Access Compliance Report

Public Rights-of-Way

(Curb Ramps)

Intersection ID: 6035	Main Street: BAXTER_CALDWELL_DR	Cross Street: JOSIE_ST	Location:	S
ADA ID: E336DB11FD50	Ramp Type: Perp	Initial Pass/Fail: Fail	Overall Compliance: No	Severity Score: 8.75
Codes/Mitigation Info/Possible Solution		Field Measurements/Component Compliance

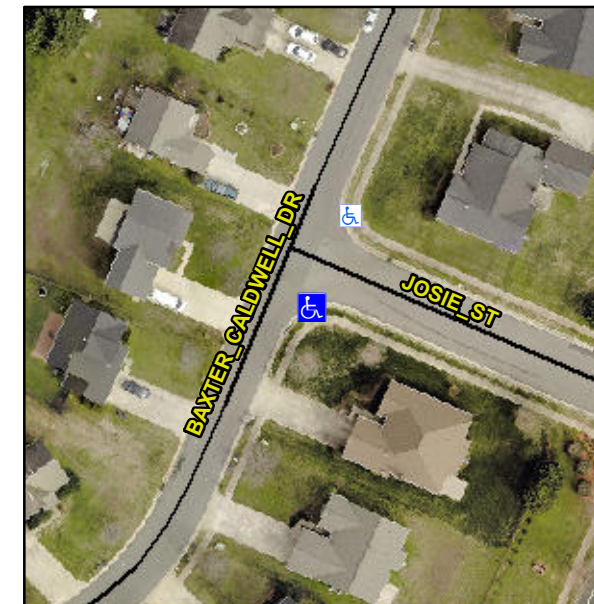
Not Found, R304.5.1

Compliance	Description	Data	Compliance	Description	Data
N/A	Ramp Length (in)	52.0	Yes	Ramp Slope (%)	5.2
No	Ramp Width (in)	39.5	Yes	Ramp XSlope (%)	1.4
N/A	Flare Type LT	N/A	N/A	Flare Type RT	N/A
N/A	Flare Slope LT (%)	N/A	N/A	Flare Slope RT (%)	N/A
N/A	Flare Traversable LT?	N/A	N/A	Flare Traversable RT?	N/A
N/A	Landing Length (in)	N/A	N/A	DWS Provided?	N/A
N/A	Landing Width (in)	N/A	N/A	DWS Contrast?	N/A
N/A	Landing Slope (%)	N/A	N/A	DWS Length (in)	N/A
N/A	Landing X Slope (%)	N/A	N/A	DWS Full Width?	N/A
N/A	Landing Curb? (Y/N)	N/A	N/A	DWS Offset (in)	N/A
N/A	Shared Landing?	N/A			
N/A	Gutter Ponding?	N/A	N/A	Gutter Slope (%)	N/A
N/A	Gutter Lip Ht (in)	N/A	N/A	Gutter X Slope (%)	N/A
N/A	Painted X Walk1?	No	N/A	Painted X Walk2?	N/A
	X Walk 1 Direction	To E		X Walk 2 Direction	N/A
N/A	X Walk 1 Width (in)	N/A	N/A	X Walk 2 Width (in)	N/A
	X Walk 1 Slope (%)	2.3		X Walk 2 Slope (%)	N/A
	X Walk 1 X Slope (%)	3.2		X Walk 2 X Slope (%)	N/A

Remove & Replace Entire Ramp.
